MIL ON with Misfire DTC(s) P0301, P0302, P0303, P0304, P0305, and/or P0306

YEAR(S)	MODEL(S)	ADDITIONAL INFORMATION
2017 - 2019	Highlander HV

Figure 1. Location of Authorized Modifications Label for 2017 – 2019 Highlander HV

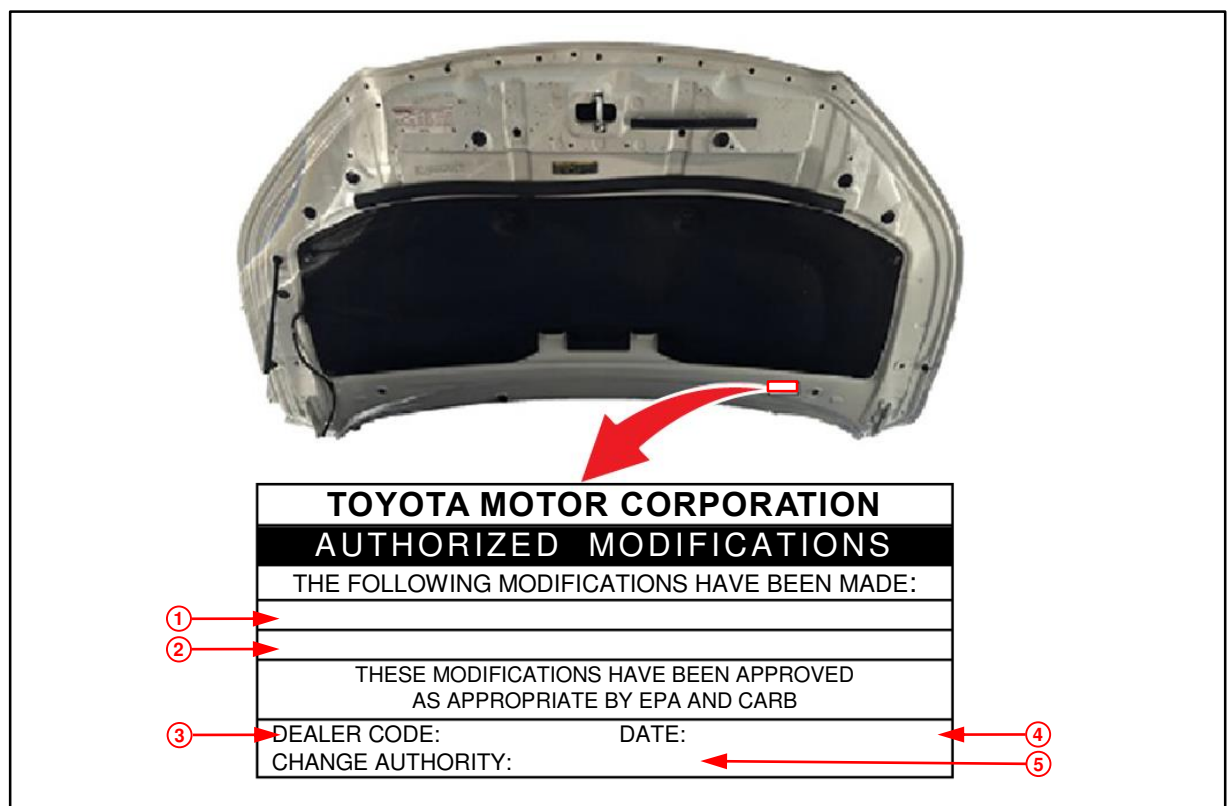
- B. Affix the Authorized Modifications Label to the vehicle at the location shown in Figure 1. The Authorized Modifications Label is available through the MDC, P/N 00451-00001-LBL.
